CALIFORNIA COASTAL COMMISSION

Th20a

6-16-0500 (SZEKERES)

CORRESPONDENCE

Revised Open Space Area

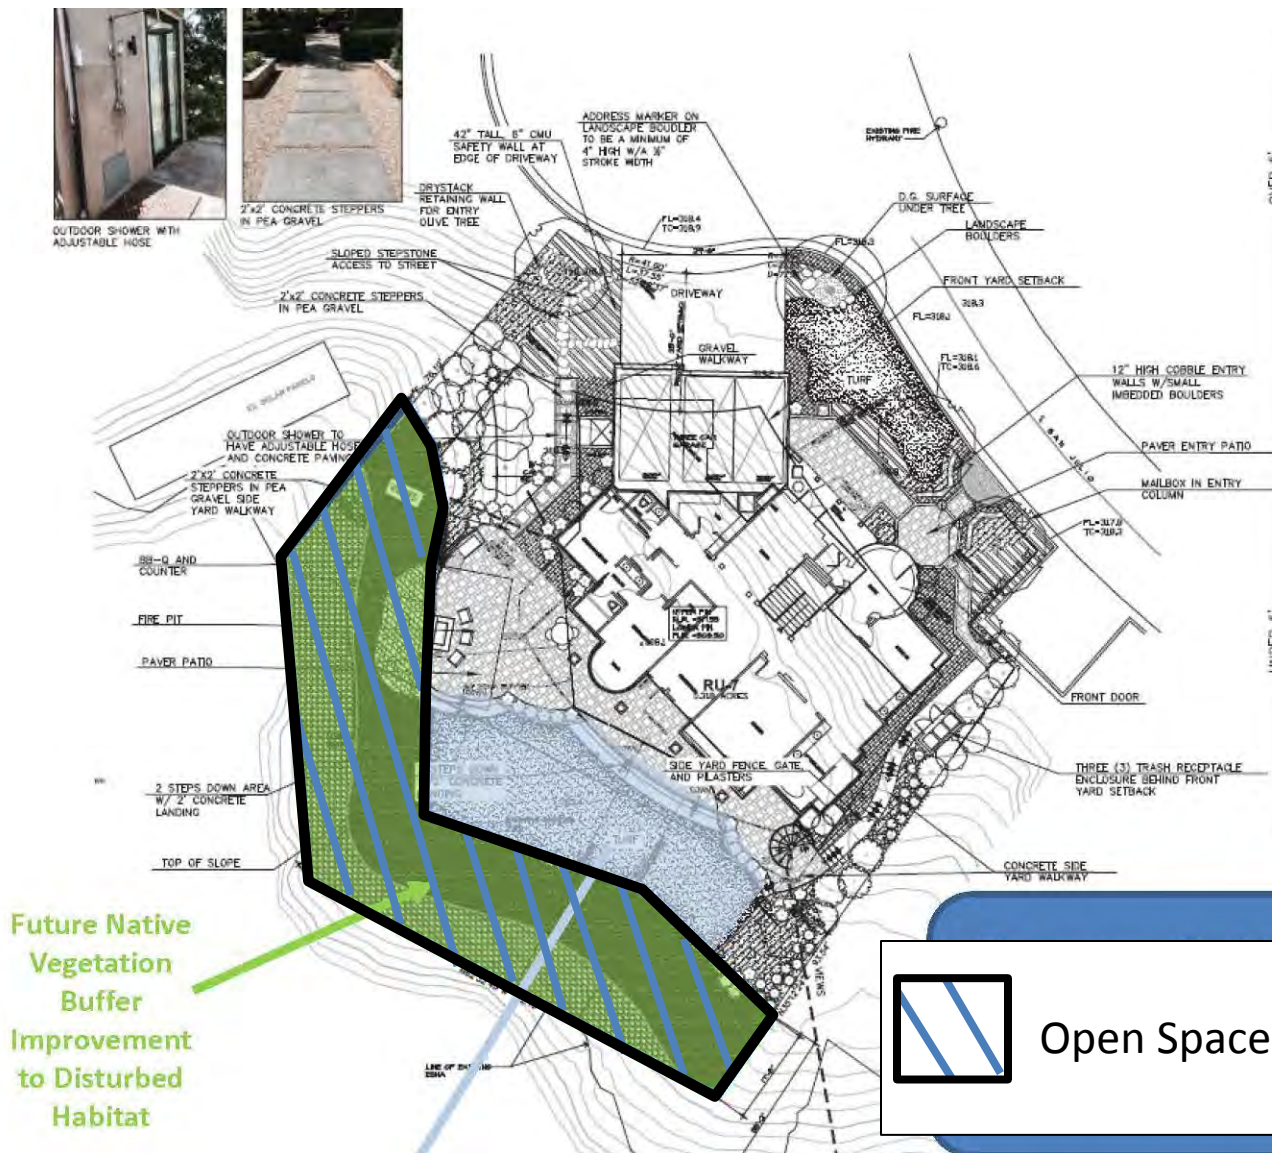
Please see the attached document, which reflects a small modification to the open space area, to exclude the corner of the retention basin. Please let us know immediately if this is what you had in mind. As Diana mentioned during our call, we are coming up on the deadline today, and we'd like to get this wrapped up as soon as possible.

Special Condition 1c requires 30 ft brush mgmt zone inland of the ESHA buffer. Your Exhibit 3 from the initial staff report and your initial revised Exhibit 10 complied with this 1c criterion. But under your new Exhibit 10 from yesterday, there is now 200-300 sq ft of native vegetation in the brush management zone where the Fire Chief will not allow it. I put this in red in the attached slide 1.

The South corner disagreement (yellow in the attached) relates to Special Condition 1a to my understanding. We can discuss that as well.

This exhibit works. I wish we could have compromised on the South corner given the ambiguity from the Commission, but I will concede here in the hope that there are no further hiccups in the process.

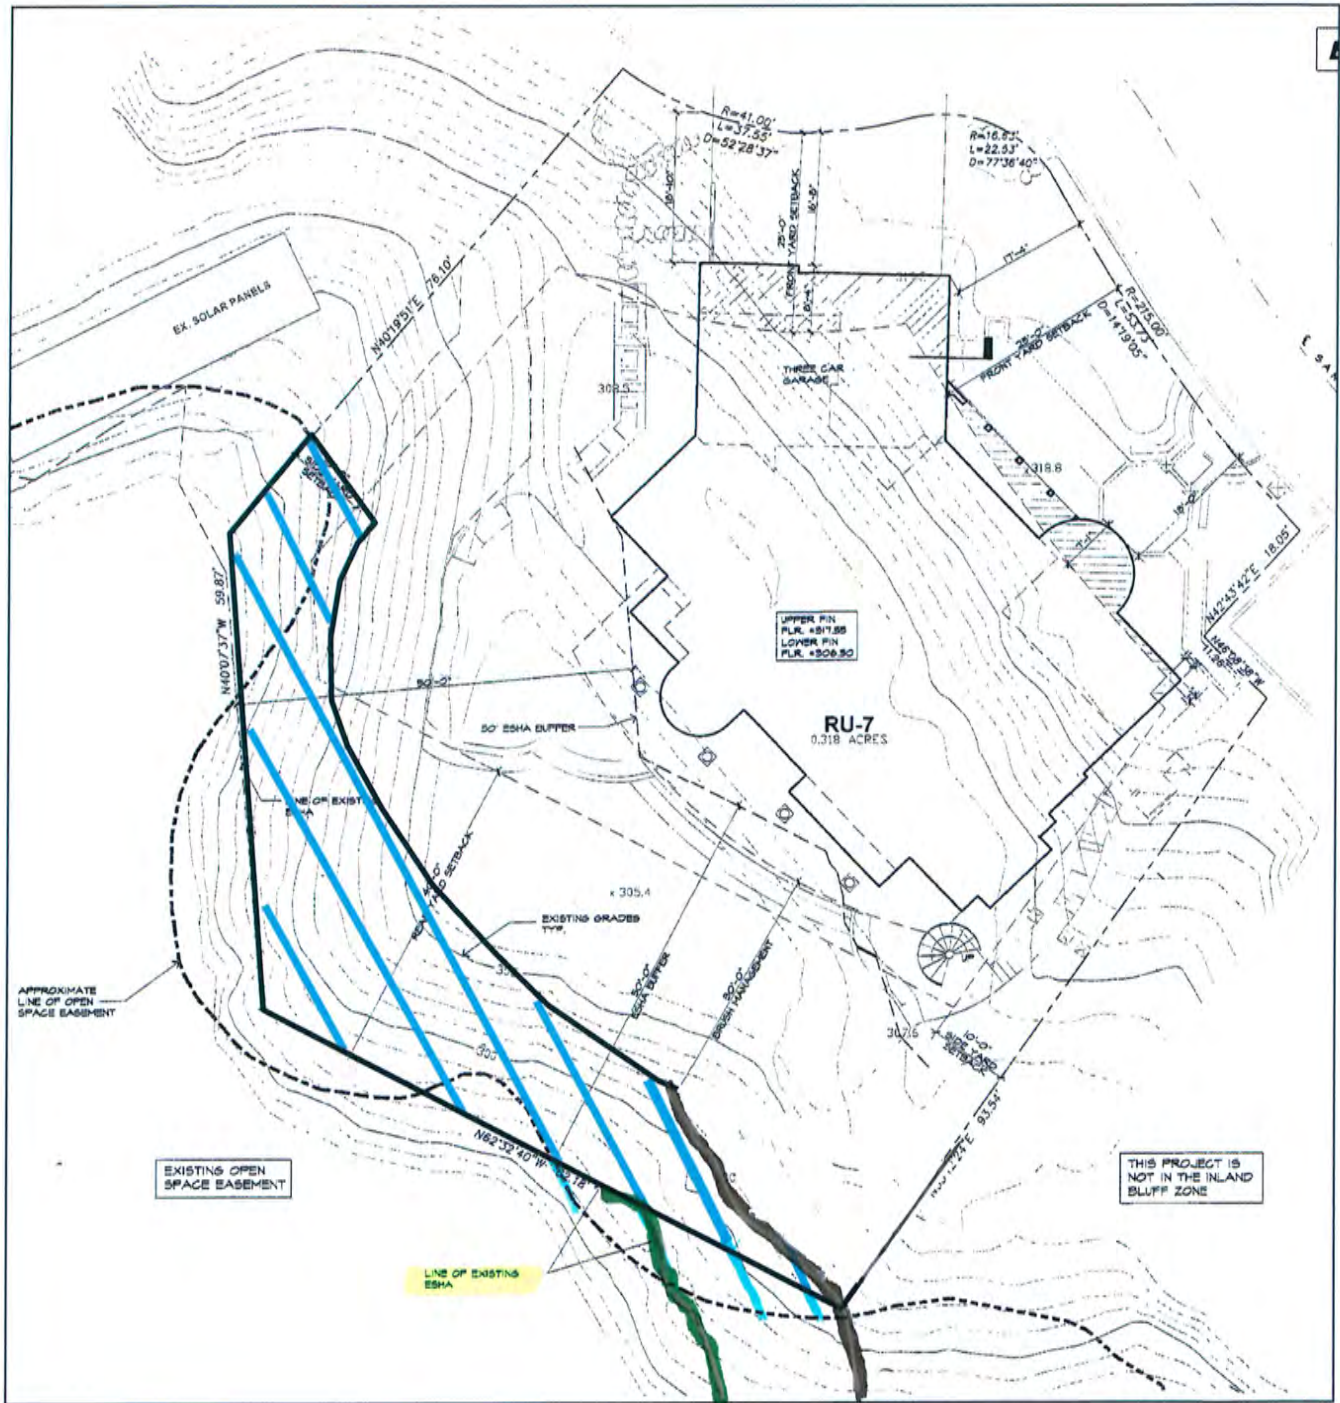
Dear Lisa - please see the attached documents, and let me know when we can talk by phone later today or tomorrow. Without the requested change to Ex. 10, the buffer in the SW corner will be about 38 feet. The Commission agreed that the buffer need be not more than 20 feet from the ESHA. The difference is that you measured from the property line. For much of the property line, the EHSA and the property line are very close. However, in the SW corner the delineated ESHA is further west. Please also see my proposed revisions to the Revised Findings, as well as Ex. 10.

Thank you for sending over the Revised Findings for the Szekeres home. As mentioned in my recent voicemail, the Commission's decision required Jeff and Amy to maintain a buffer that is no less than 20 feet from the EHSA. However, the Revised Findings and Exhibit 10, state that the buffer is measured from the property line, not the ESHA (e.g., see Staff Notes on page 1). We believe this error can be remedied with just a few changes to the Revised Findings and a small modification to Exhibit 10 at the southwest corner of the property. Please see the attached redline to the Revised Findings and my revision to Exhibit 10.

We respectfully request that the Revised Findings and Exhibit 10 be modified as indicated on the attached documents.
